PRELIMINARY ASSESSMENT REPORT

***For the connection of the Five Nations Energy Inc. Project
to the 115kV circuit C6R: Abitibi Canyon GS to Moosonee DS***

CAA N^o. 2000-015

FIVE NATIONS ENERGY PROJECT AT MOOSONEE

Diagram 1 shows the proposed arrangement.

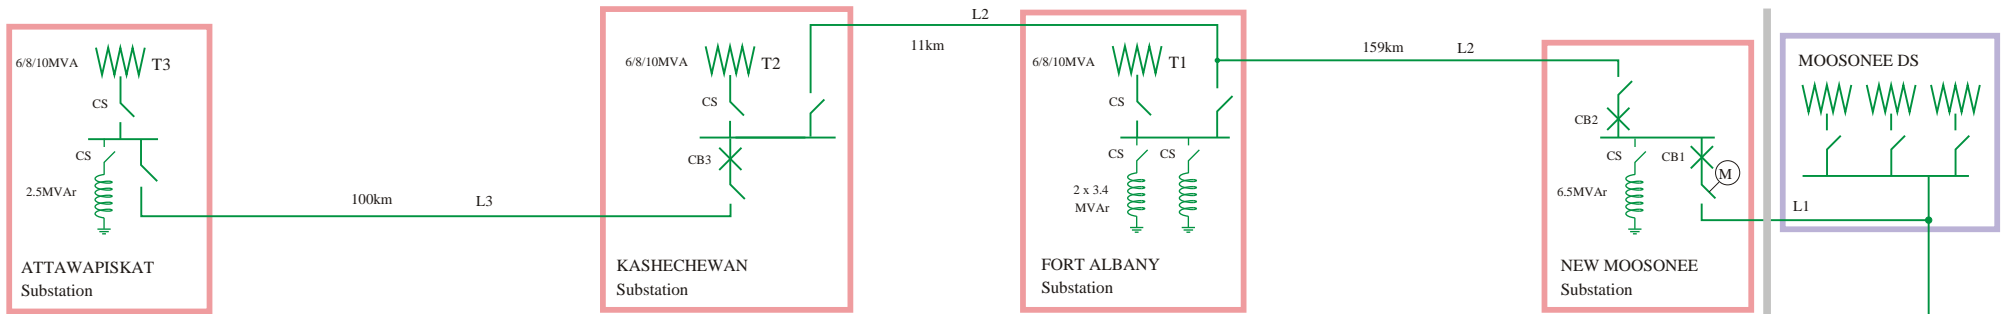
The design proposed by Five Nations Energy Inc. does not include facilities to provide a transfer trip capability to the 115kV circuit breakers at Abitibi Canyon GS in the event of a breaker failure condition at the New Moosonee Substation. In order to address a breaker failure condition, Five Nations Energy Inc. has therefore proposed an arrangement with two, series-connected circuit breakers at the New Moosonee Substation.

In the event of a fault on the new 115kV transmission line, trip signals are to be sent to both circuit breakers simultaneously to ensure rapid fault clearance if one breaker should fail to operate.

In addition, since a shunt reactor is to be connected between the two circuit breakers at the New Moosonee Substation, a trip signal is to be sent to the circuit switcher associated with the shunt reactor (at the same time as the trip signals are sent to the two circuit breakers). This action is required to ensure that the reactor does not remain connected to circuit C6R in the event of a breaker failure condition involving circuit breaker CB1.

A busbar fault at the New Moosonee Substation, involving any of the equipment connected between the two circuit breakers, would only have circuit breaker CB1 available for fault isolation. To address a possible breaker failure condition involving circuit breaker CB1, a signal to open the disconnect switch associated with circuit breaker CB1 is to be sent simultaneously with the trip signal to the circuit breaker. For this reason the disconnect switch must be motorised.

- i. The disconnect switch associated with circuit breaker CB1 at the New Moosonee Substation must be motorised.
- ii. For a line fault, simultaneous trip signals are to be sent to circuit breakers CB1 & CB2 and to the circuit switcher associated with the shunt reactor at the New Moosonee Substation.
- iii. For a busbar fault at the New Moosonee Substation, involving any of the equipment connected between the two circuit breakers, circuit breaker CB1 is to be tripped and simultaneously a signal is to be sent to open the motorised disconnect switch.
- iv. The implementation of the responses, as detailed in 2.3 above, to alarms or ‘lock-out’ conditions involving either of the circuit breakers at the New Moosonee Substation.
